December 23, 1992
LD-92-123

Docket No. 52-002

Subject: Closure of System 80+™ Draft Safety Evaluation Report Issues

Figure 2.5.25.1-4.8 - Spectral match of time history and CMS3 target spectrum
(Vertical Direction, Damping 1, 2, 5, 7%)

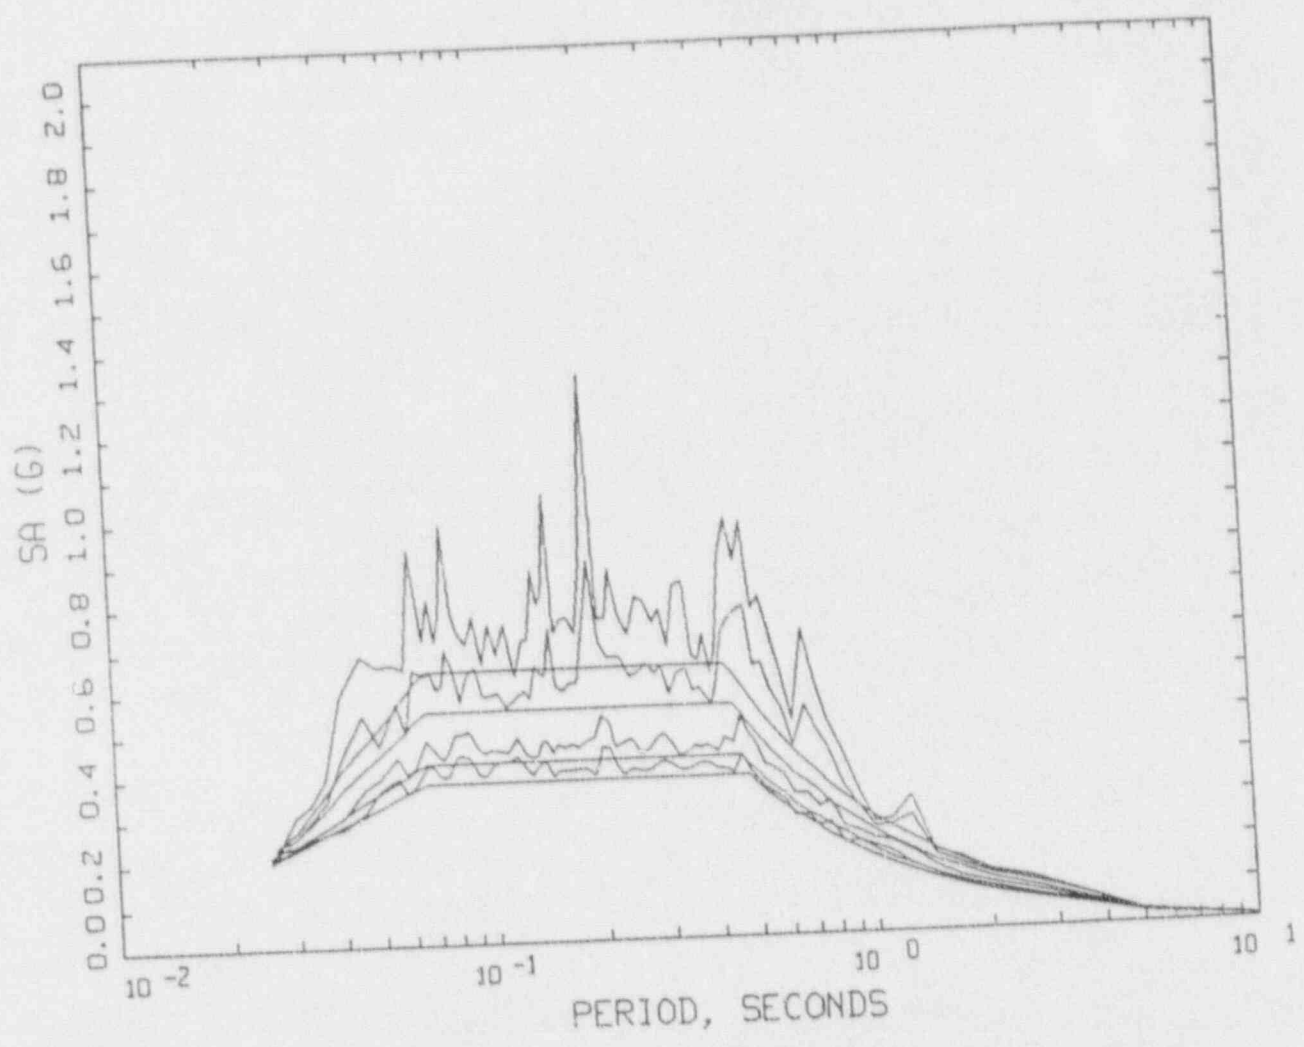
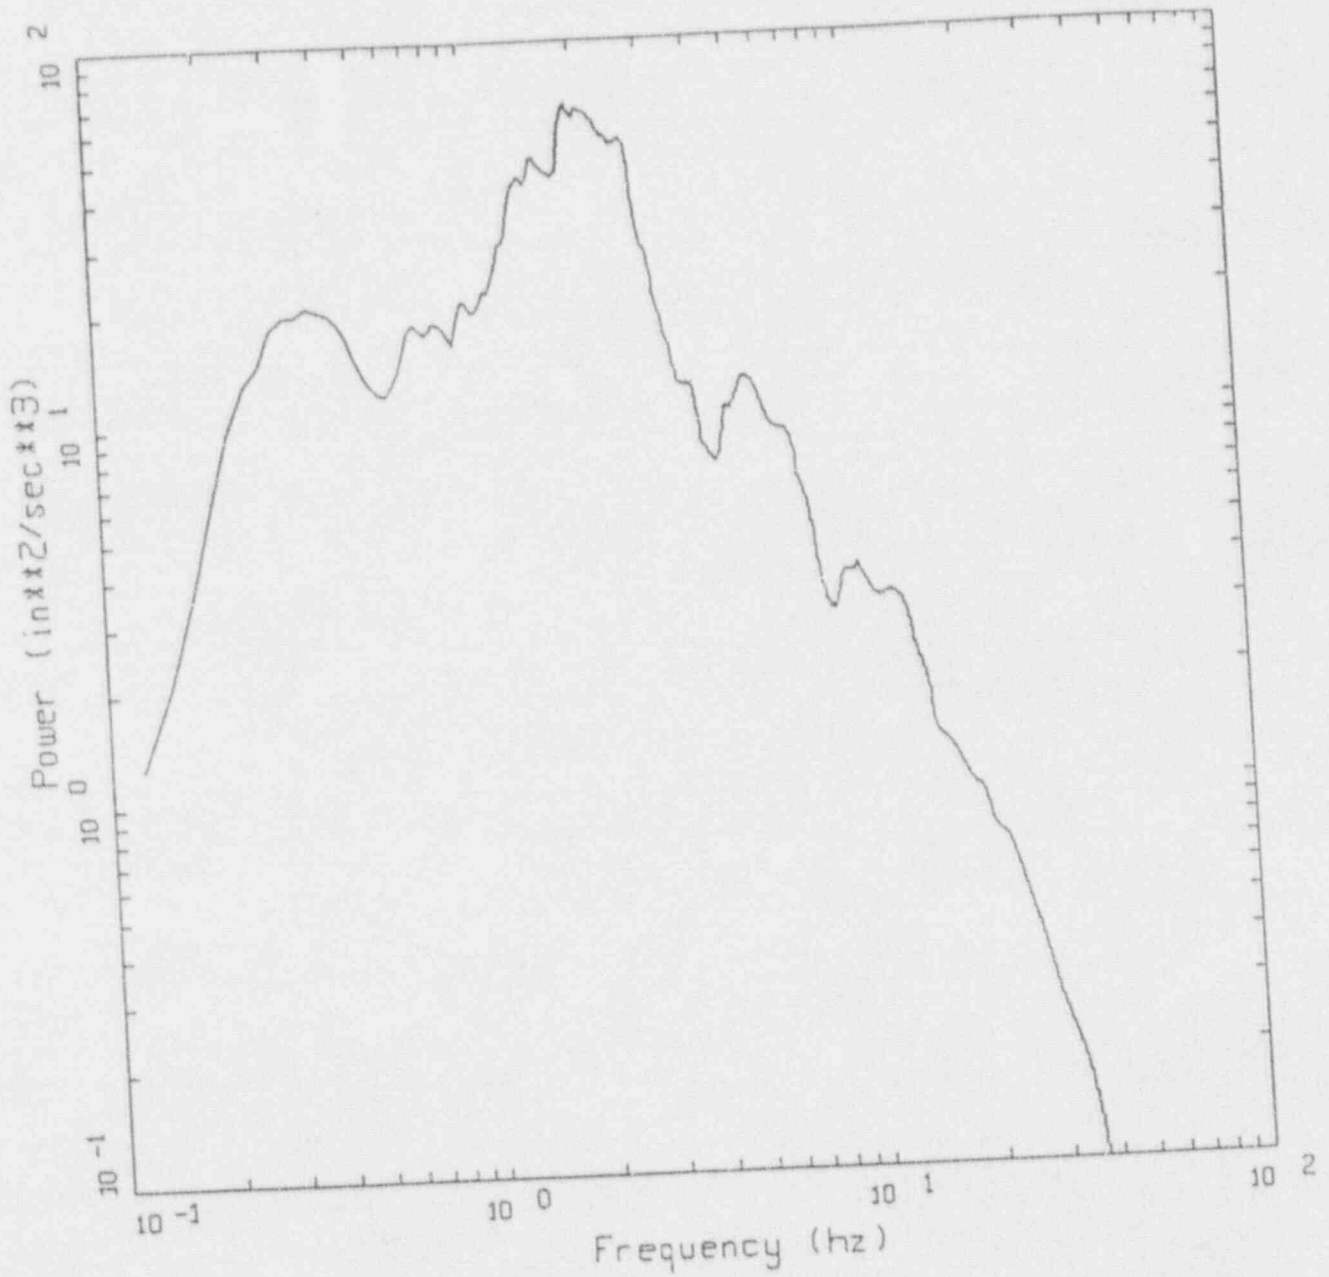
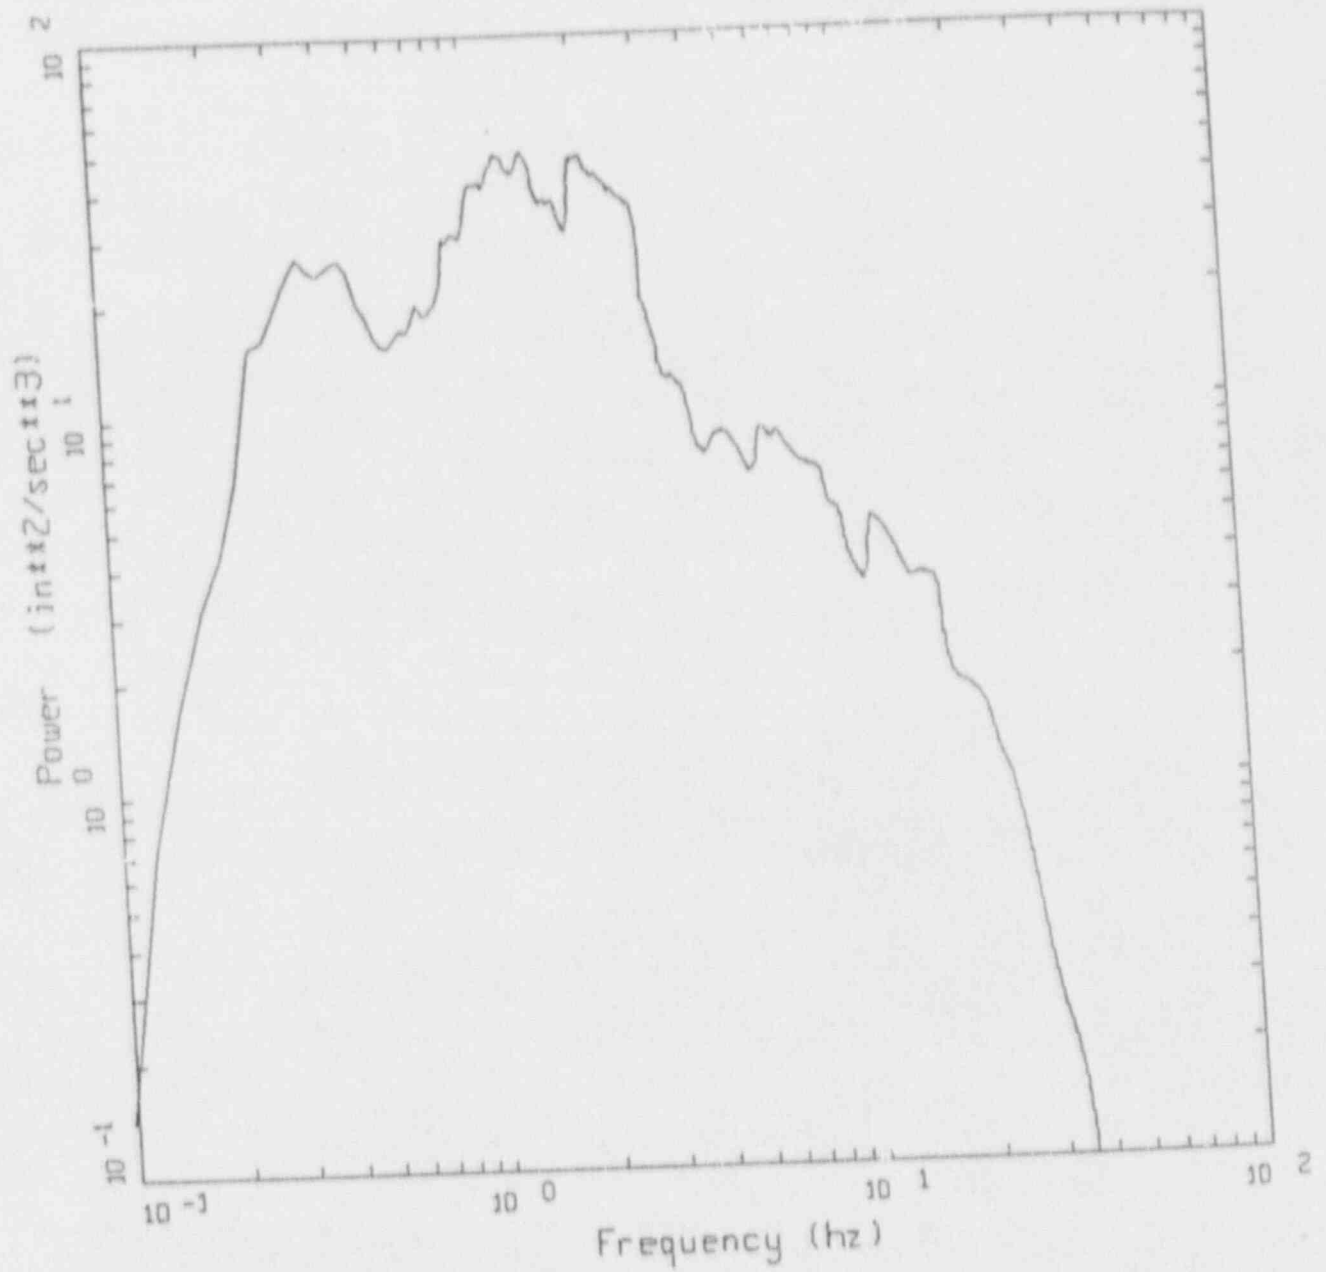
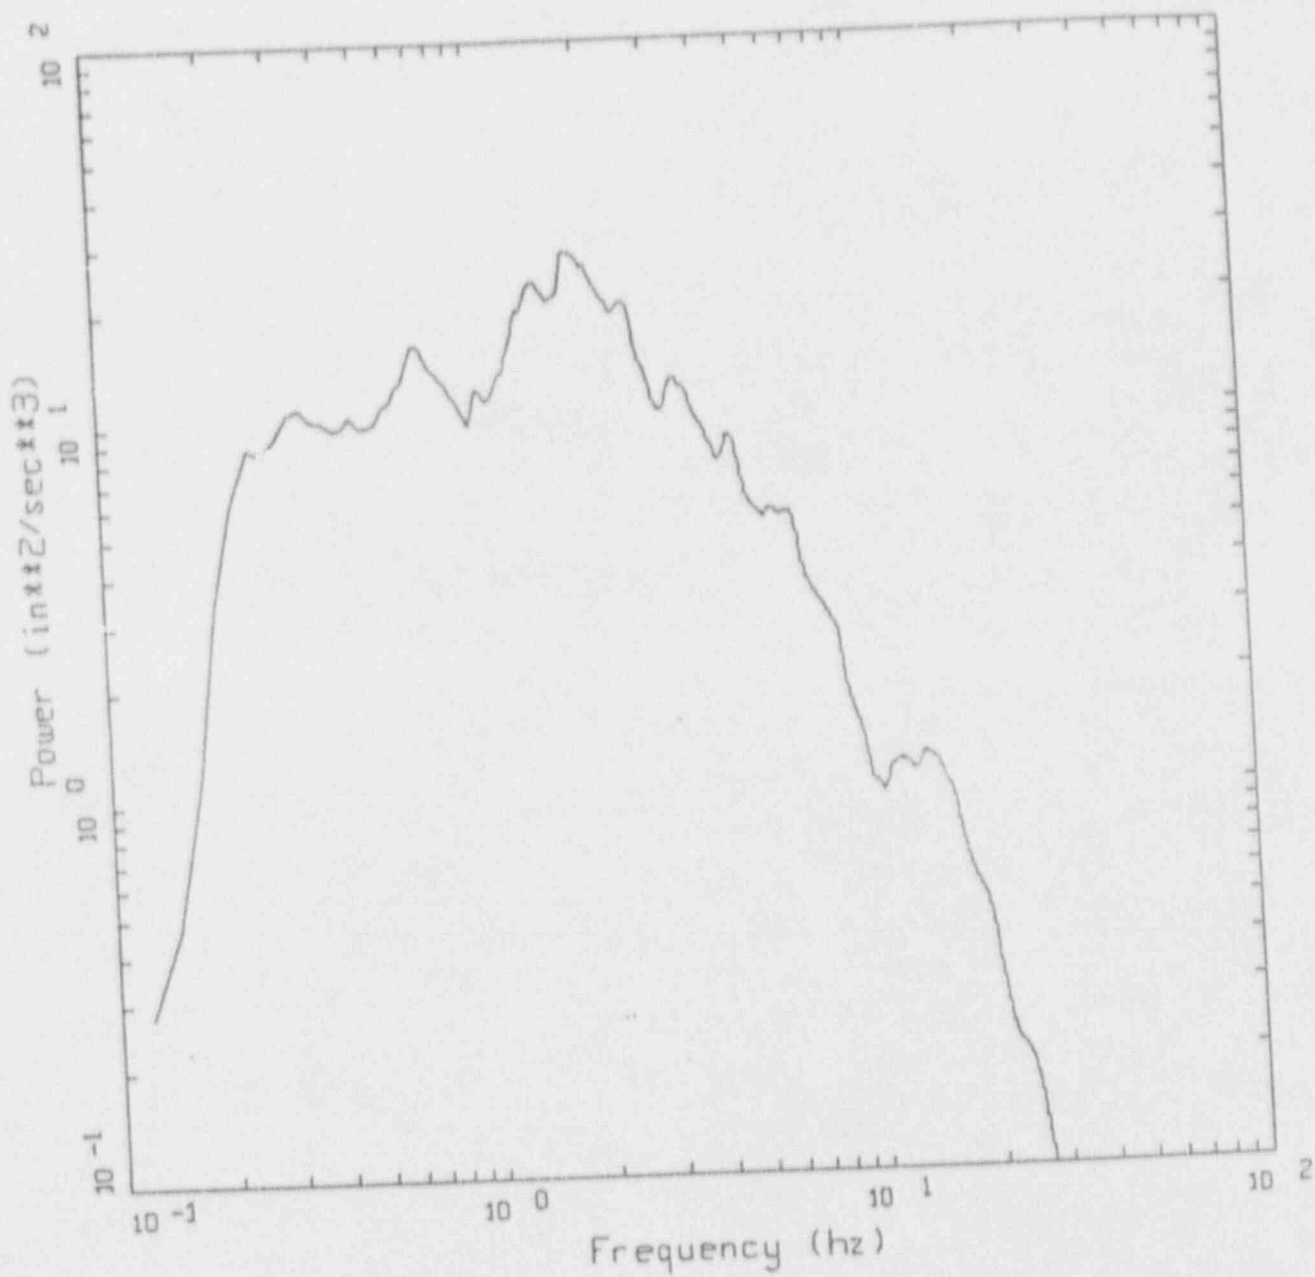
The CESSAR should be revised to include CMS1 and CMS3.

The CESSAR is being revised to include the CMS1 and CMS3 time histories, the corresponding spectra match at 1, 2, 5 and 7% damping and the CMS1 and CMS3 Power Spectral Densities. Figures 2.5.2.5.1-4.1 through 2.5.2.5.1-4.11 show the information that will be included in the CESSAR. All time histories meet the SRP criteria for development of artificial time histories. CMS1 meets the SRP 3.7.1, App. A requirements for Power Spectral Density (PSD) for the horizontal motions, as shown in Figure 2.5.2.5.1-4.4. In addition, it is shown in Figures 2.5.2.5.1-4.5 and 2.5.2.5.1-4.8 through -11 that the PSD of the vertical CMS1 time history and all three time histories of the CMS3 motion have adequate PSD's with no deficiency in power at any frequency range.

Figure 3.2 - Outline of Application of Control Motion CMSI in SSI Analyses

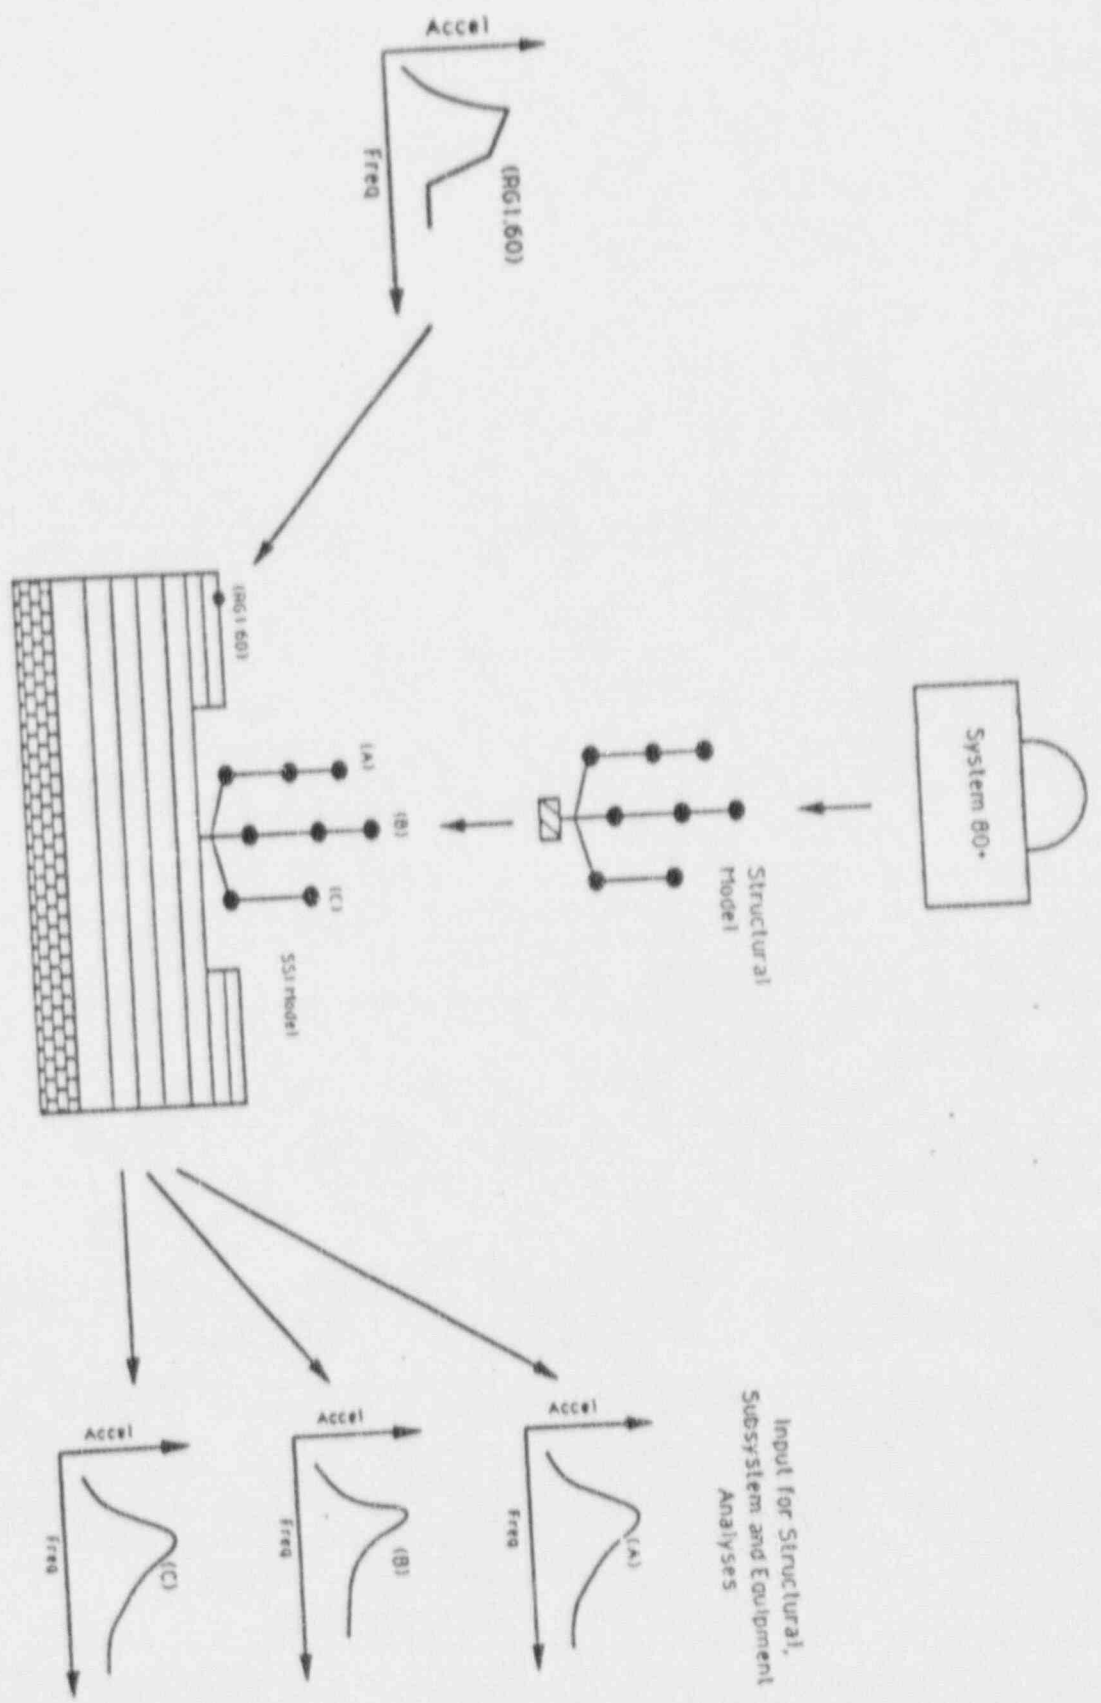
Open Item 2.5.2.5.1-4

The analytical procedure that will be followed to generate in-structure response spectra and design loads for the System 80+ structures and components using CMS1 is shown in the schematic of the following page. CMS1 is applied at the free-field ground surface of each generic soil profile. The strain-iterated soil properties of each profile where CMS1 is applied are derived from the soil analysis using the CMS2 motion. Therefore, the foundation impedances and the transfer functions at the structures are the same for the analyses of all three motions, CMS1, CMS2 and CMS3.

The usage of the in-structure response spectra for the design of the System 80+ structures and components is discussed in the response to Open Item 2.5-1. The procedures outlined in the response to Open Item 2.5-1 are applicable to all three motions, CMS1, CMS2 and CMS3.
